TECHNICAL BULLETIN LM204-011 14 JUN 2006

<u>SECTION: 204-05</u> Range Rover (LM) - Vehicle Lowers Overnight (Air Spring Leak)							
. .	,	ers Overnight		iy Leak)			
AFFECTED VEHIC	JLE RANGE:						
Range Rover (LM)	Model Year: Up to 2005						
		VIN:	Up to 4A	160029			
MARKETS:							
CONDITION SUM	MARY:						
Situation: A customer may report a concern that the vehicle ride height lowers overnight.							
Cause: Investigation reveals no obvious system leaks, but inspection of the air spring assembly on higher mileage vehicles (30000- 60000 miles), shows hairline cracks in the rubber at the base of the front air spring. Particularly at the point where the airspring rolls over the plastic base. An air leak at this point can be confirmed using a suitable leak detector fluid.							
Action: Should a customer express concern regarding the above, refer to the Service Instruction detailed in this bulletin to renew the airspring for new units with a modified spring material.

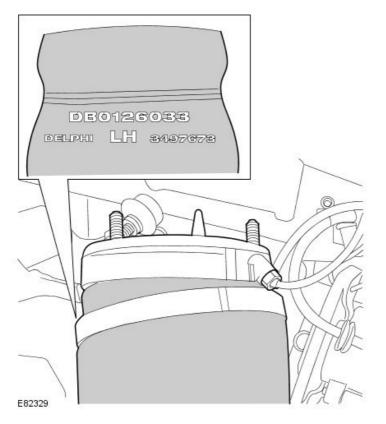
1. Airsprings with modified spring material can be identified the manufacturer markings printed on the air bag:

> 1. Righthand air springs must start DC01.

2. Left-hand air springs must start DB01.

2. Renew the front air spring where necessary. For additional information, refer to Range Rover (LM) Workshop Manual Section 60 - FRONT SUSPENSION, Air spring assembly (60.21.01).
